**STAFF REPORT  
(Preliminary Plat)**

**CASE NUMBER:** S/D 91-11 - NEW BEDFORD PLACE 2ND ADDITION

Re: S/D 91-11 (Preliminary Plat) New Bedford Place 2nd  
Addition

STAFF REPORT  
(Final Plat, Preliminary Plat Approved 3/7/91)

VICINITY MAP:

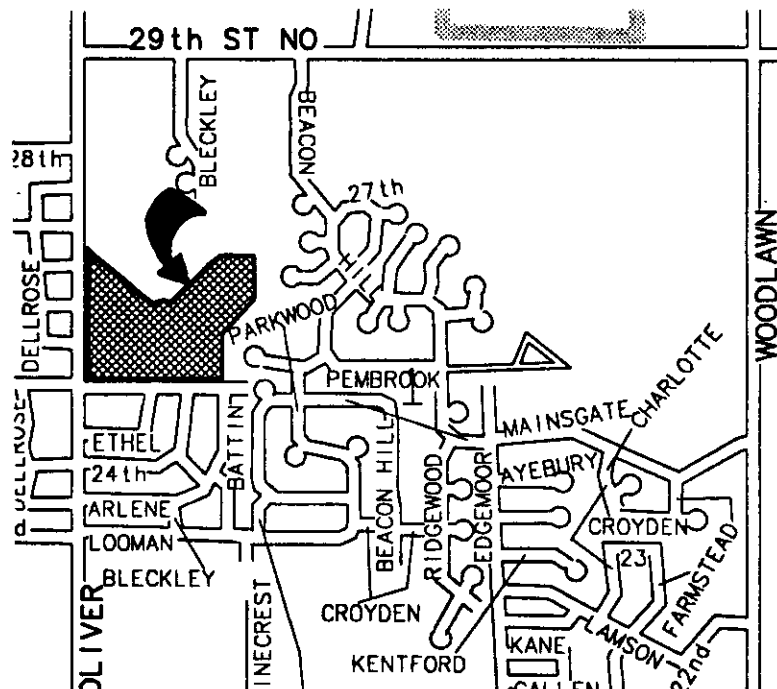
NOTE: This addition is a portion of an overall preliminary plat, the Beacon Hill 2nd Addition, which was reviewed by the Subdivision Committee, August 9, 1990. However, the applicant has submitted this plat as a preliminary since a fairly substantial difference in street layouts are involved between this plat and the overall preliminary. This site is also within the Beacon Hill Community Unit Plan DP-147. Block 1 in the area of Oxford Lane Ct. corresponds to Parcel 11 of the C.U.P., while the remainder of Block 1 and all of Block 2 correspond to Parcels 10 and 12 of the C.U.P.

- E. The applicant shall guarantee the paving of the proposed interior streets. For the narrow, 32-foot public streets, these guarantees shall provide for a 29-foot paving standard.

- F. Originally, the preliminary plat indicated a portion of an overall sidewalk system in the area of this plat, extending from Oliver, eastward in a reserve south of lots adjacent to Oxford Lane. Since that reserve strip is no longer being platted, a sidewalk shall be included in the paving petition for Oxford Lane and the Bleckley-Pembroke-Glendale loop.

- G. As is indicated by the preliminary plat, the northern half of 25th Street North, adjacent to the south line of Block 1 is not being dedicated. Existing platted lots south of this street are therefore not being provided a full public street for access. This situation has, however, been addressed in the C.U.P. which indicates that various off-site improvements will be required to terminate or provide access for the properties and north-south streets (Battin, Bleckley Ct., Glendale, turnaround for 25th St.) being affected by this plat. The applicant shall therefore provide guarantees for these off-site improvements as depicted on this plat and the associated C.U.P.

- J. The applicant is advised that if the area of this plat, which corresponds to parcels 10 and 12 of C.U.P., DP-147 are planned for conventional single-family type housing, that the C.U.P. will need to be adjusted. The plat is depicting 75 lots, but under the C.U.P. only 55 single-family lots (units) can be provided.

- K. Prior to the plat being scheduled for City Council review, the applicant shall submit a vacation request for the areas of 25th Street North indicated to be vacated due to this plat and shall obtain and submit to Planning, the dedication, by separate instrument, of the right-of-way required for the turnaround shown for 25th Street North, just east of Oliver.

- L. Since this plat proposes the platting of narrow street right-of-way with adjacent "15 and 20 foot street, drainage and utility easement," a restrictive covenant shall be submitted which calls out restrictions for lot-owner use of these easements. Retaining walls and change of grade shall be prohibited within these easements as well as fences, earth berms and mass plantings. Any planting within the easement shall be reviewed by the City Forestry Division prior to installation.

not be located in what would be the front yards of lots, but be located in a reserve established for common open space. The parking easements in Block 1 do not meet these criteria and shall therefore not be indicated on the final plat.

- S. The final plat shall indicate the recording information for the 50-foot gas line easement on this property.
- T. Because of the discontinuity of Block 1 on this plat, on the final plat, the area around Oxford Lane Ct. should be labeled as a separate Block 3. It should also be noted that within this section two (2) lots have not been numbered. An unnumbered lot is shown between Lots 2 and 3 and Lots 7 and 8. Consequently, lots will need to be renumbered in this area, as will the lots in the remaining portion of Block 1.

- U. On the final plat, in order to better locate the "20 foot", Drainage and Utility Easement on Block 1, for certain of the lots (7 thru 10) additional dimensions should be provided from the street right-of-way line to this easement.

VICINITY MAP:

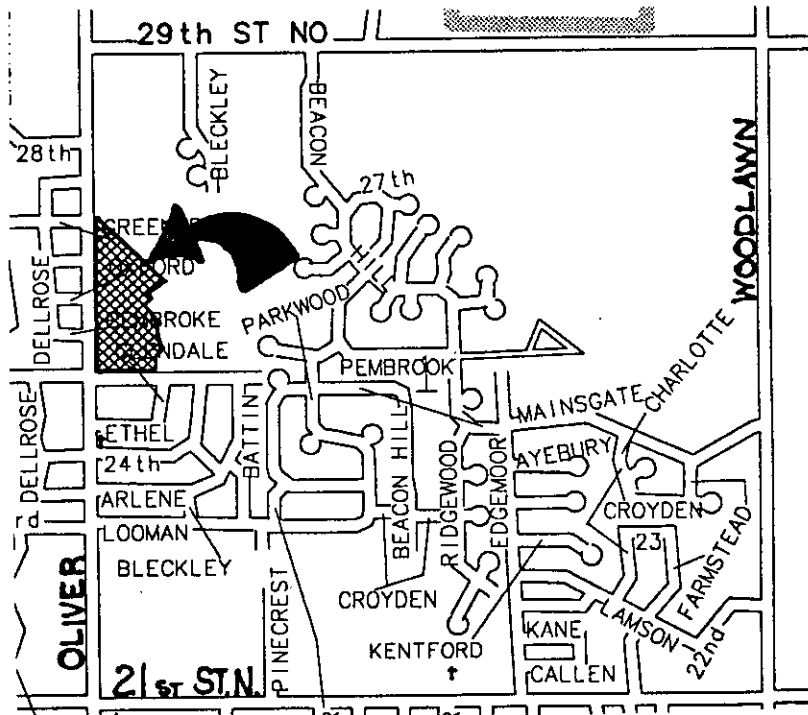
NOTE: This plat involves only a portion of a preliminary plat reviewed by the Subdivision Committee March 7, 1991. That preliminary, however, was only a portion of another preliminary plat, named the Beacon Hill 2nd Addition, which was reviewed by the Subdivision Committee on August 9, 1990. Further, this site is within the Beacon Hill Community Unit Plan DP-147. In terms of this final portion, Block 1 corresponds to Parcel 11 and Block 2 to the west half of Parcel 10 of the C.U.P.

- F. Originally, the preliminary plat indicated a portion of an overall sidewalk system in the area of this plat, extending from Oliver, eastward in a reserve south of lots adjacent to Oxford Lane. Since that reserve strip is no longer being platted, the applicant is proposing an alternate sidewalk system. The proposed system places sidewalk along the north side of Oxford Lane, going eastward to Bleckley Circle, then north up this Circle until just south of the turnaround it crosses eastward and heads into a drainage or open space reserve area. It is recommended that this alternative sidewalk plan be accepted and the sidewalk be guaranteed as part of the paving guarantee.

- G. As was indicated by the preliminary plat, the northern half of 25th Street North adjacent to the south line of the preliminary plat is not being dedicated. Existing platted lots south of this street are therefore not being provided a full public street for access. This situation was, however, addressed in the C.U.P. which indicates that various off-site improvements will be required to terminate or provide access for the properties and north-south streets (Battin, Bleckley Ct., Glendale, turnaround for 25th St.) being affected by platting of the properties to the north. The applicant shall therefore provide guarantees for these off-site improvements as depicted on the associated C.U.P. and in the area of this final plat from Oliver to just east of Glendale.

- I. As was indicated during review of the preliminary plat the applicant shall obtain an adjustment to the C.U.P. to allow for the number of single-family lots being proposed by this final and the preliminary plat. Specifically, conditions for parcels 10 and 12 of DP-147 need to be appropriately adjusted.

- O. As was indicated during review of the preliminary plat, in order to plat parking easements under City Council policy statement 13, in addition to being in a safe location and not in what would be the front yard of lots, such easements are to be in a Reserve,

which is itself platted for other open space uses. As part of a Reserve, ownership and maintenance of the easement area is to be placed in the responsibility of a homeowner's association. These parking easements were not intended to be simply placed on a plat as a portion of some lot or lots. Technically or legally the involved property owner retains ownership of these sites and likely can use it for purposes in conflict with parking.

At the least the areas shown as parking easements should be shown as reserves and listed as such in the plat's text. The ownership and maintenance of these areas should be included in the covenant for Reserves. Further, the face of the plat should indicate these Reserves in addition to the detailed drawings.
